UNITED STATES PATENT AND TRADEMARK OFFICE

09/590,380

Gerard Hotier

| Office Action Summary | Application No. | Applicant(s) | |

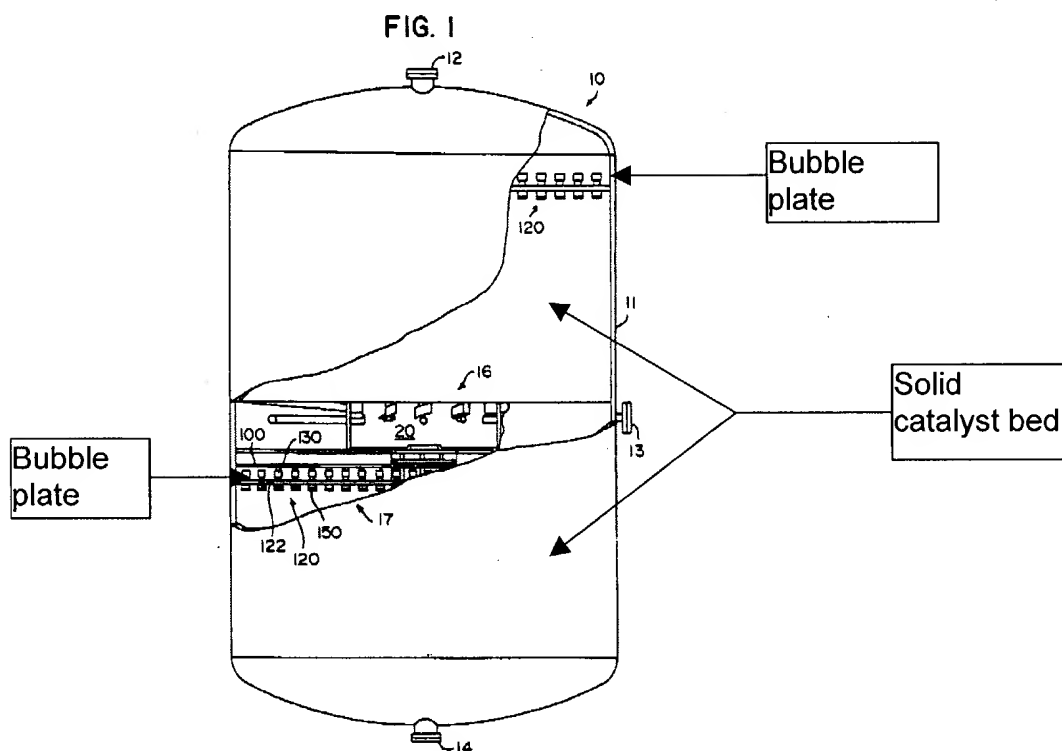
With respect to claim 6. A Mat element according to claim 1, comprising an approximately cylindrical mat element (Fig.2).

With respect to claim 7. A Mat element according to claim 1, comprising connecting means (64) arranged at at least its lower end and/or its upper end.

With respect to claim 8. A Mat comprising on at least a part of its length at least one element having the characteristics of claim 1. Examiner notes that the rejection of claim 1 provides for rejection of claim 8.

With respect to claim 9. A Device for bringing at least one fluid into contact with a solid, comprising at least:

- one chamber (10);

- a mat arranged approximately along the axis of said chamber (16);

- several spaced levels of distributor plates (120);

- a solid bed arranged between two plates (Fig.1)
